TOSHIBA CORPORATION
Toshiba Electronic Devices & Storage Corporation

Date: September 17, 2026
Ref. No.: DO2026-00004E-H1

Notice of change in packing material (cover tape)

1. Product to be Affected	:	39 Target Products (See Attached List)
2. Description of Change	:	Target part: Cover tape material manufacturer Company A→ Company B

◆ Changed member

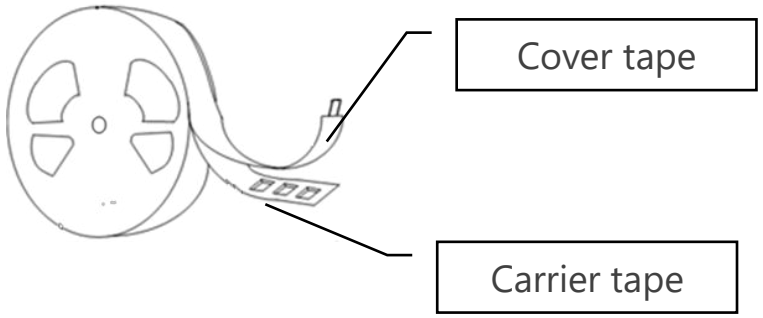
Cover tape : 13.3 / 21.0 mm width

Current	Change
Cover tape manufacturer	Company A	Company B
Main material	PET	PE

2. Changes : Details of the change

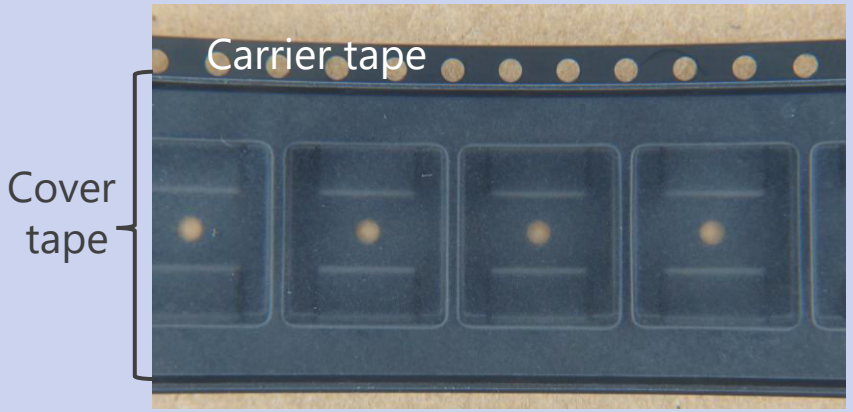
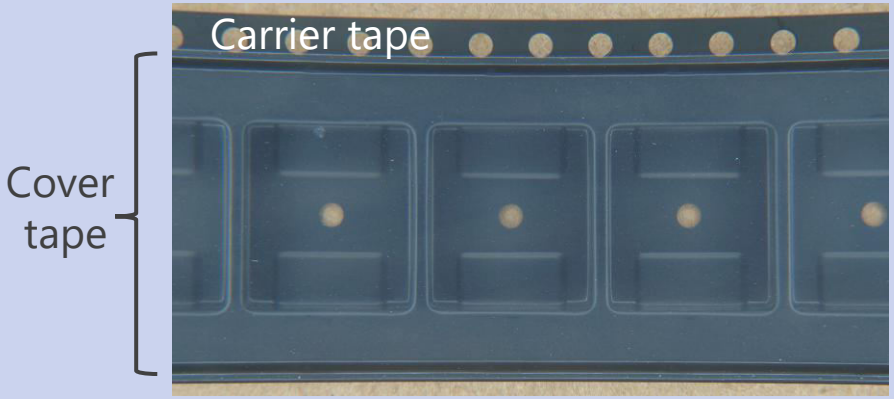
◆Change point: Change details

item	Current product	Changed product
Cover tape manufacturer	Company A	Company B
Main material	PET	PE
Transmittance	≧90%	88%
Haze	≦45%	11%
Appearance

We have confirmed that the visibility is equivalent.

5. Evaluation 13.3mm Width

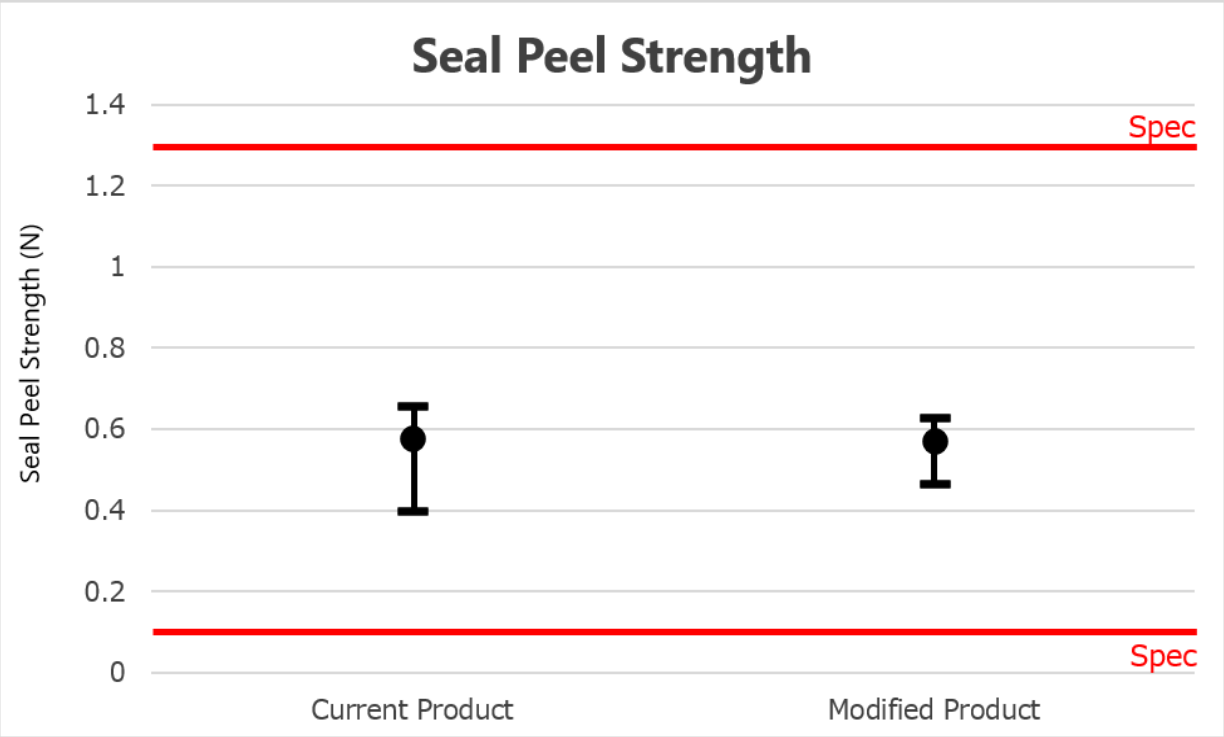
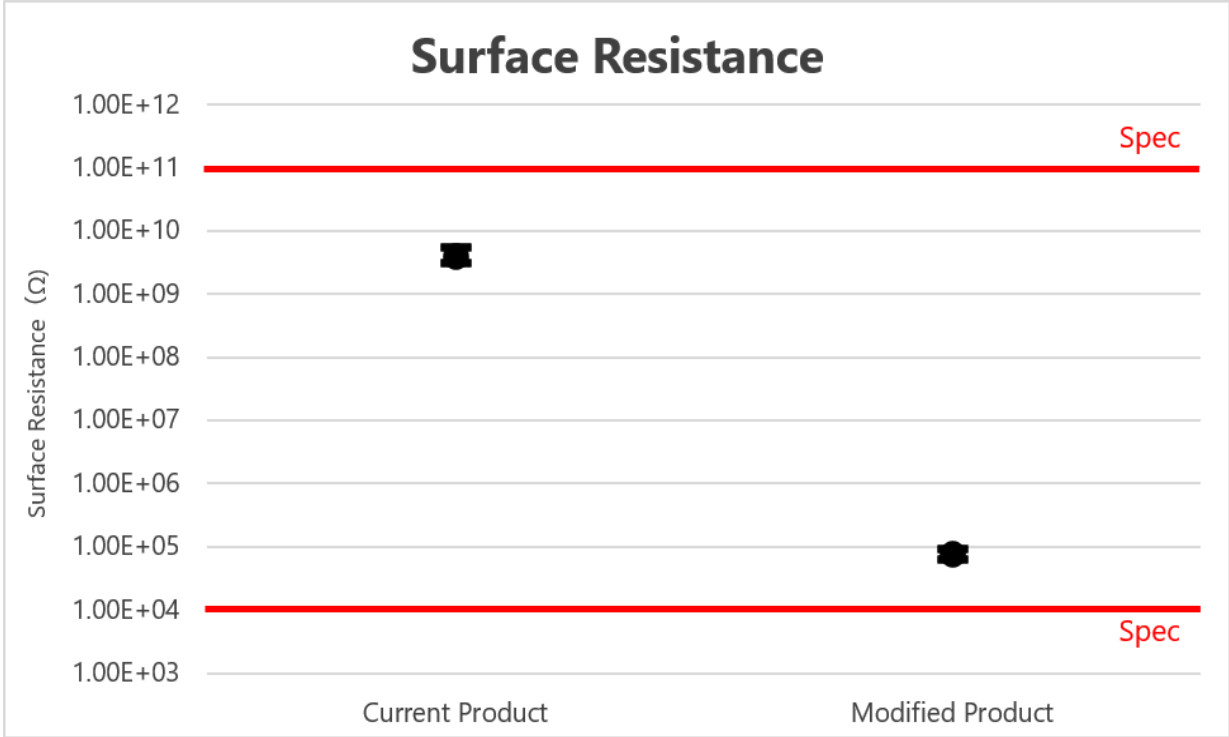
Evaluation Item	Quantity	Acceptance Criteria	Judgment Result
Seal Peel Strength	1pcs	0.1～1.3N	Pass
Surface Resistance	5pcs	1×10^{4}～1×10^{11} Ω	Pass

We have confirmed that all evaluation results are within the specified standards.

5. Evaluation 21.0mm Width

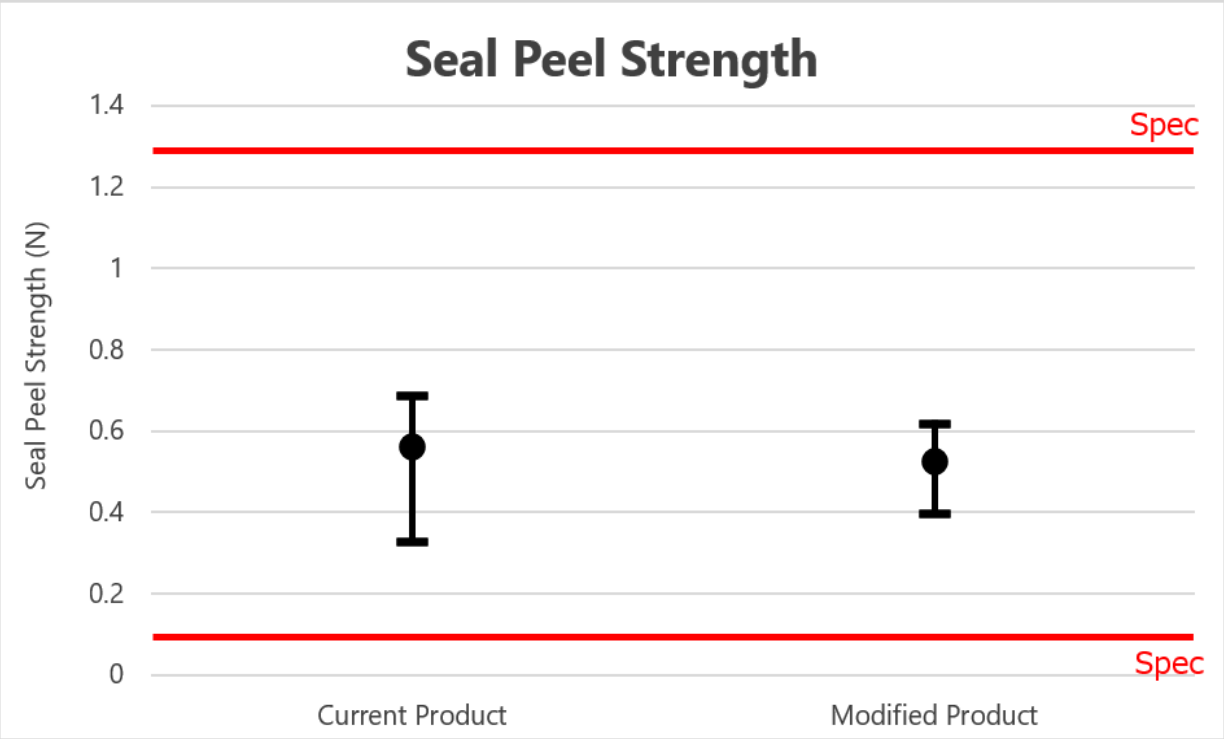
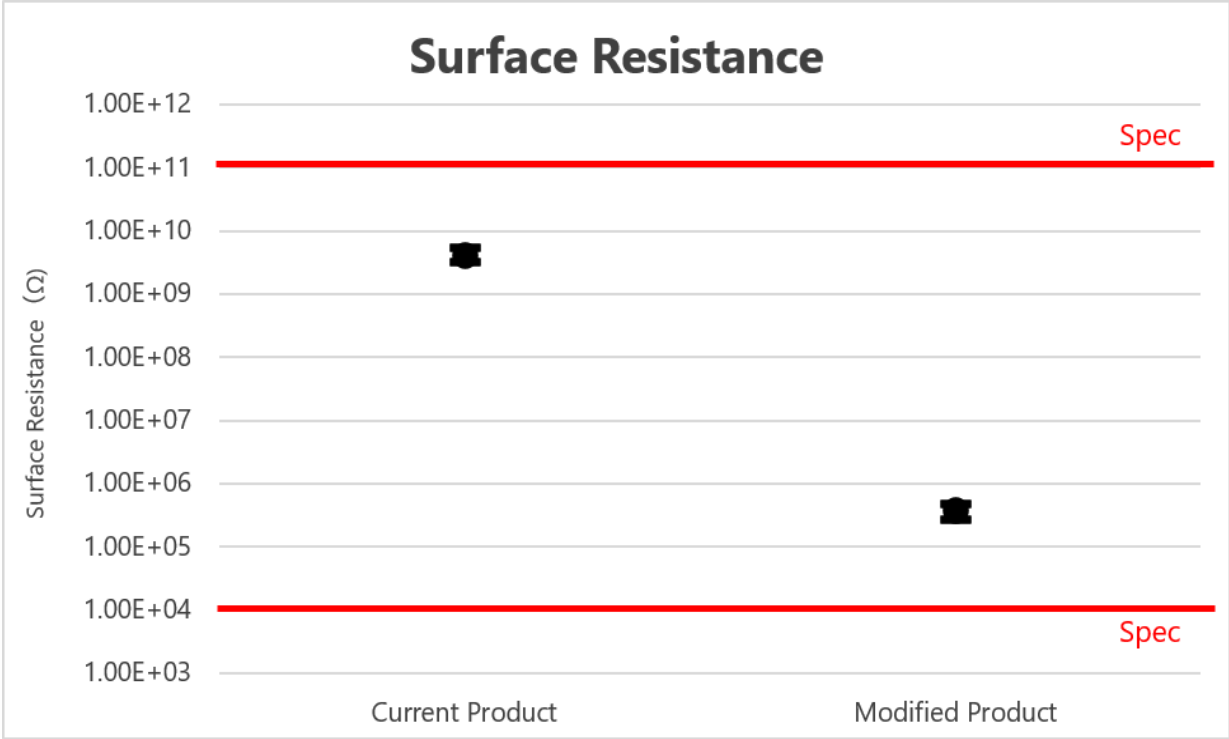
Evaluation Item	Quantity	Acceptance Criteria	Judgment Result
Seal Peel Strength	1pcs	0.1～1.3N	Pass
Surface Resistance	5pcs	1×10^{4}～1×10^{11} Ω	Pass

We have confirmed that all evaluation results are within the specified standards.
